RESPONSE TO REQUEST FOR ADDITIONAL INFORMATION

APR1400 Design Certification

Docket No. 52-046

RAI No.: 211-8236
SRP Section: 09.02.01 - Station Service Water System
Application Section: 9.2.1
Date of RAI Issue: 09/14/2015

Figure 9.2.1-1 Essential Service Water System Flow Diagram

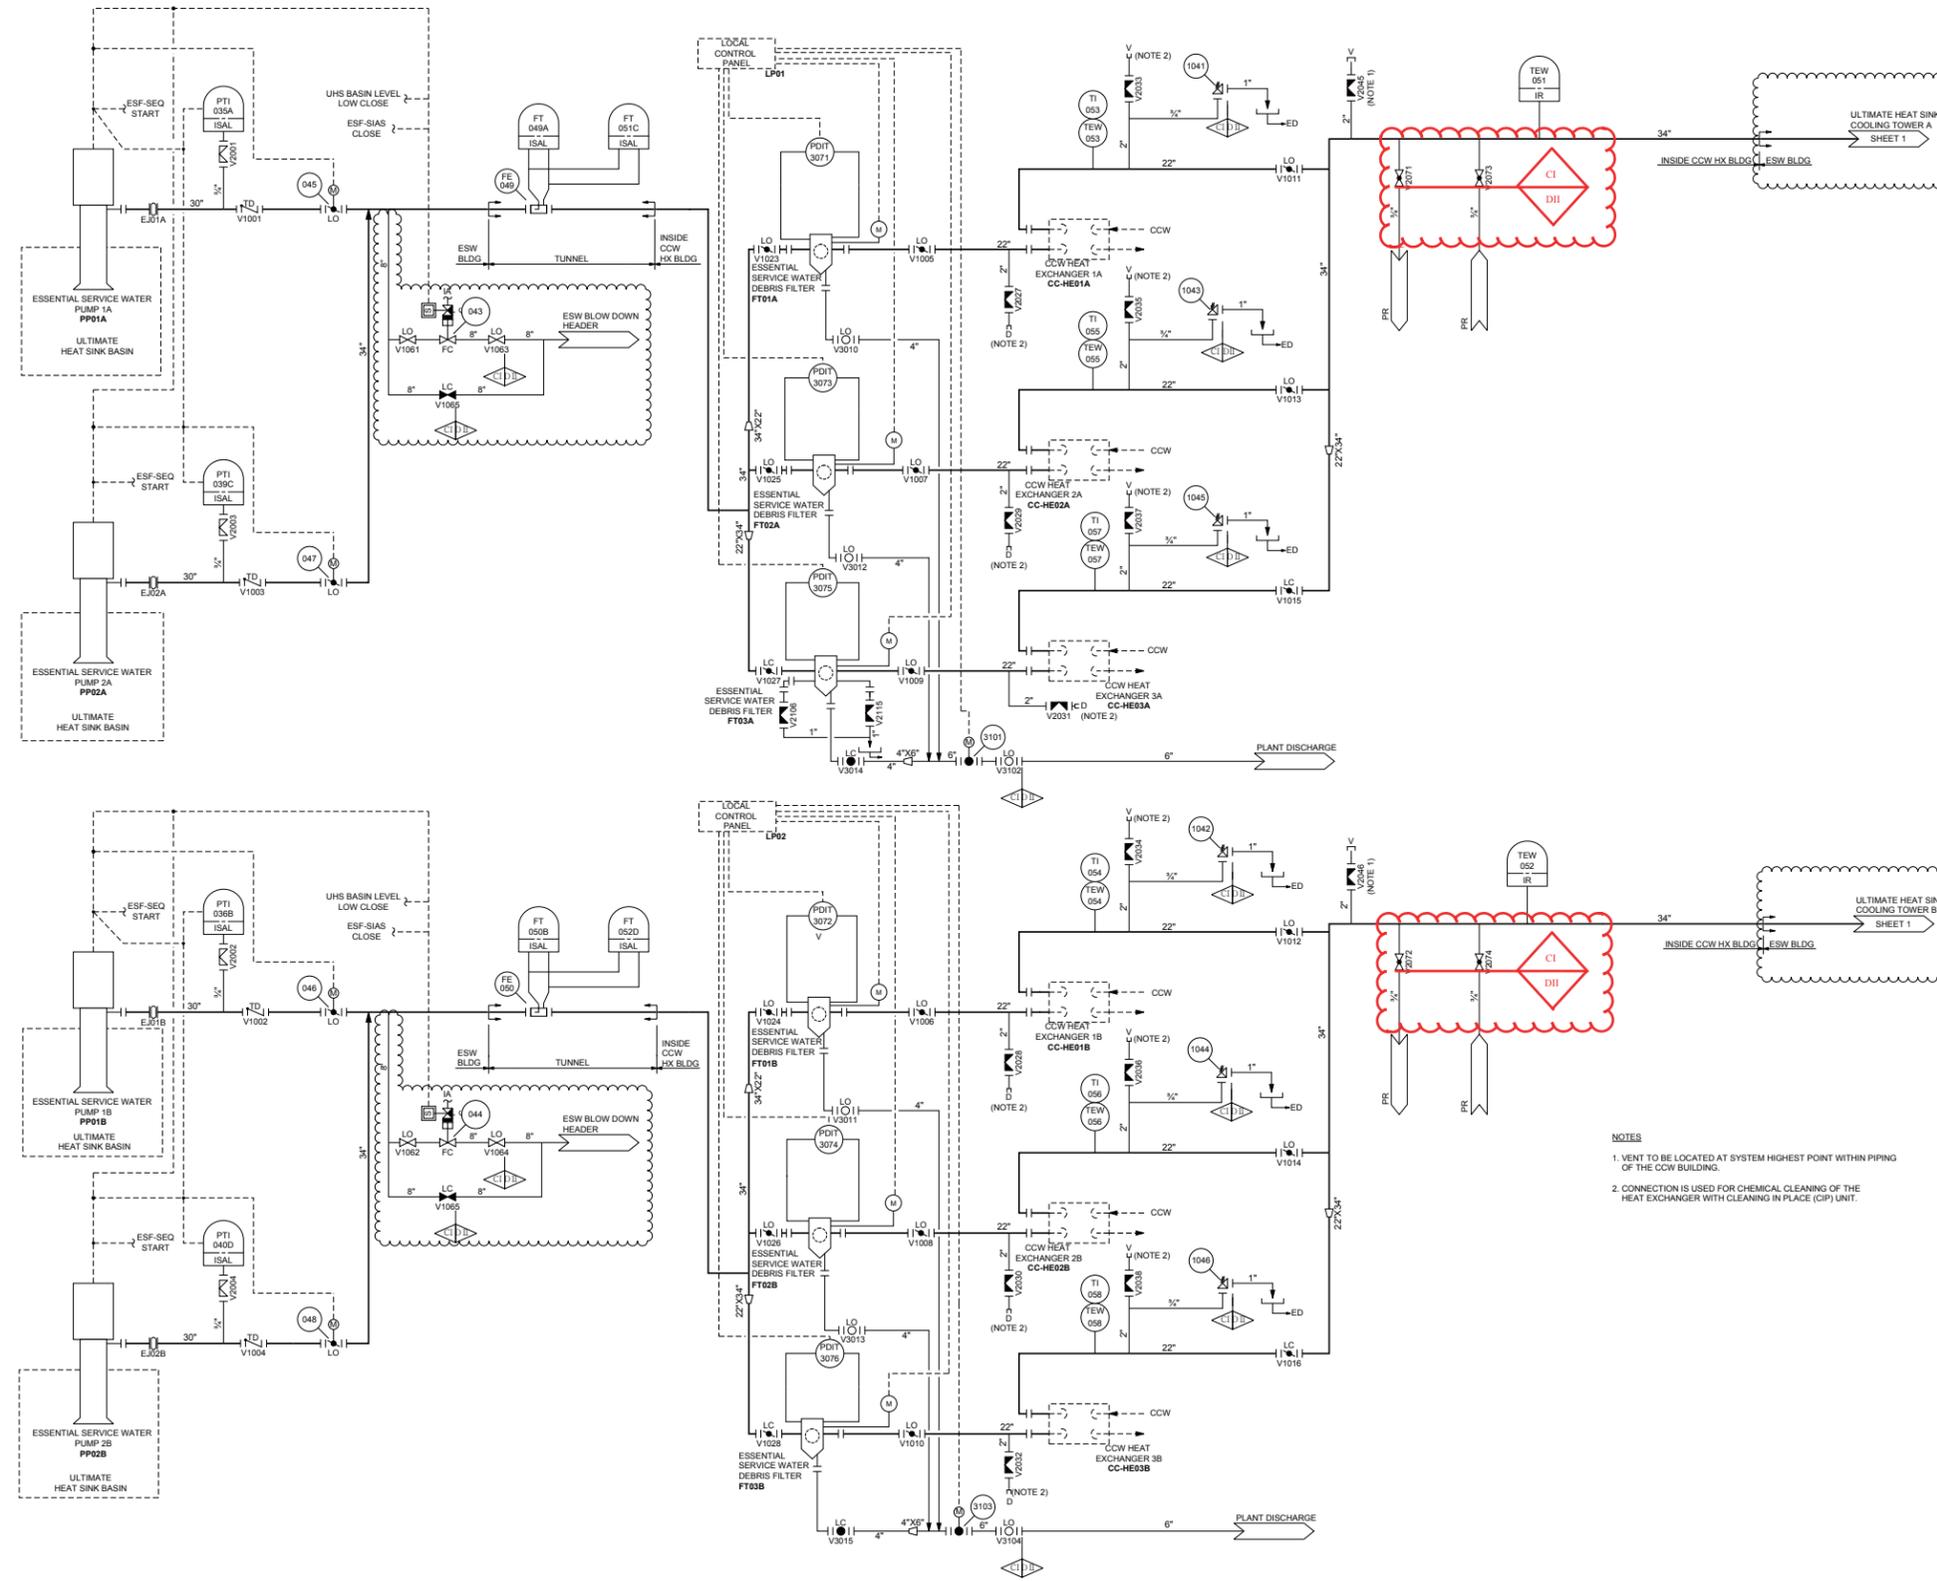
The staff finds that DCD Tier 2, Section 9.2.1 lacks information such as demonstrating how the ESWS conforms to Position C.2 in RG 1.29 where the failure of nonsafety-related SSCs would not result in the failure of safety-related SSCs. Also missing is the identification of the boundary isolation valves separating the nonsafety- from the safety-related portions of the ESWS.

The applicant is requested to demonstrate that the ESWS conforms to RG 1.29 Position C.2 including the identification of boundary isolation valves. These valves should be listed in DCD Tier 2, Table 3.2-1, with their safety classification and seismic qualification. Also requested is a clarification on whether these boundary isolation valves are included for inservice testing and inspection.

The boundary isolation valves separating the non-safety related portions from the safety related portions are SX-1063 thru 1066, SX-2071 thru 2074, SX-3102 and 3104. These valves are classified safety related and Seismic Category I.

Figure 9.2.1-1 will be revised to indicate the classification break of the piping portion to the radiation monitoring system.

Figure 9.2.1-1 will be revised as indicated on the Attachment.
